APPLICATION FOR PERCOLATION TESTING AND SITE EVALUATION

SUBDIVISION/PROPERTY NAME SPENCE PROPERTY

RE: 2825 Florence Road
PERC CERT PLAN/OSDS PLAN

The perc cert plan for 2825 Florence Road has been reviewed with the following comments:

AP 563977

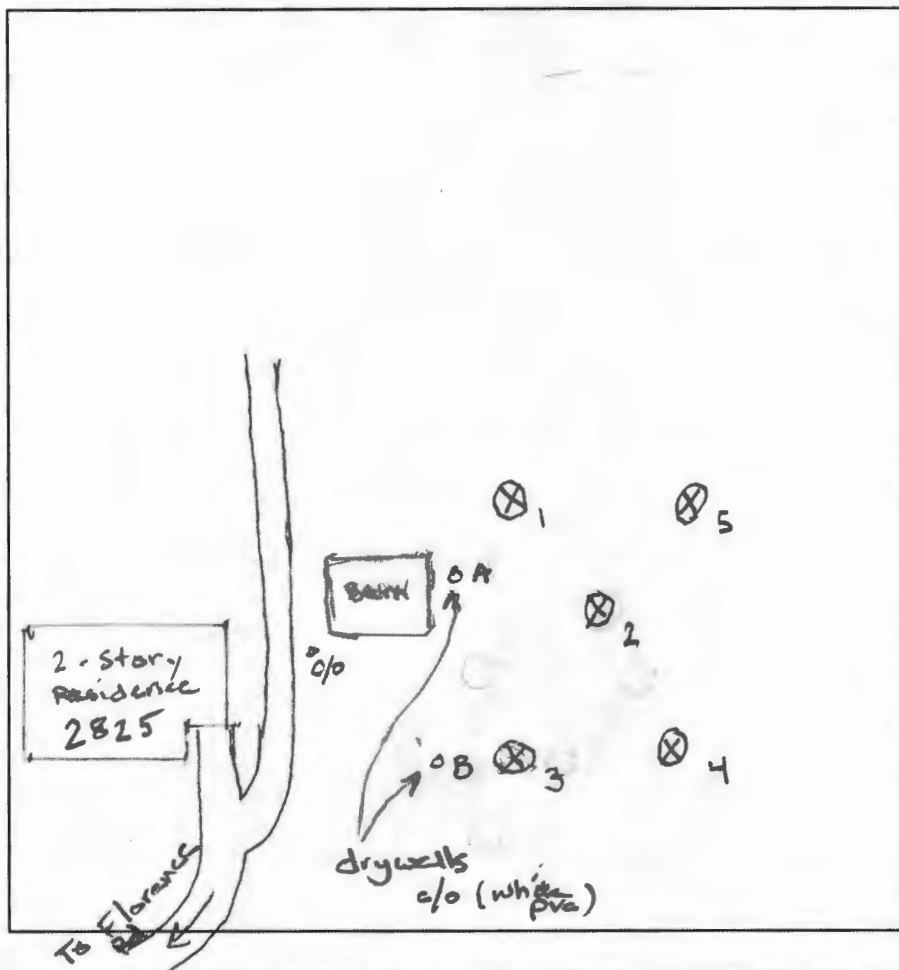
Based on today's liquid measurements/discussion with Fogles about drywell diameters and invert depths (printed on field notes), the existing drywells are good for 230 gallons/day. DW A = 125 sq. ft. , DW B = 162 sq. ft. Total = 287 sq./ft. x 0.8 rate = 230 gal/day (i.e. 4 bedroom x 150 gallons/day/bedroom = 600 gallons/day. You may opt to keep the drywells but the system is currently undersized and a trench will need to be added. Additional, the drywells must also be brought up to code by installing a vertical perforated pipe & filled with stone.
